TSG RAN Meeting #18   **RP-020799**
New Orleans, US, 3 - 6 December, 2002

Title   **CRs (Rel-5) to TS 25.141**
Source   **TSG RAN WG4**
Agenda Item   **7.4.5**

⌘   **25.141** CR **263**   ⌘ **rev** **1** ⌘   Current version: **5.4.0** ⌘

Title: ⌘	Addition of TX Diversity timing accuracy test
Source: ⌘	RAN WG4
Work item code:⌘ TEI5	***Date:*** ⌘ 26/11/2002

Figure B.6: Measuring system set-up for time alignment error in TX diversity

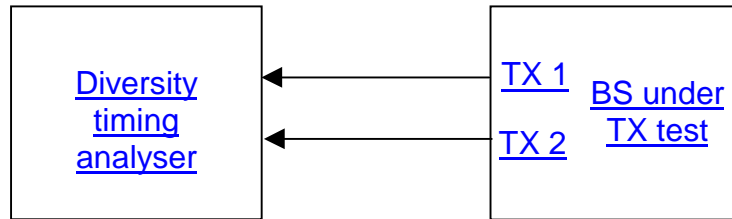
Reason for change: ⌘	A timing accuracy spec has been added to 25.104 CR 146 for TX diversity timing alignment. This change adds the corresponding test case.
Summary of change:⌘	Addition of new test case. Correction of editorial errors in test tolerance table references.
Consequences if not approved: ⌘	There will be no test and if the diversity timing error is not correct, TX diversity will not work.

1) Connect both base station RF antenna ports to the measurement equipment according to figure B.6.

# B.1.6 Time alignment error in TX Diversity
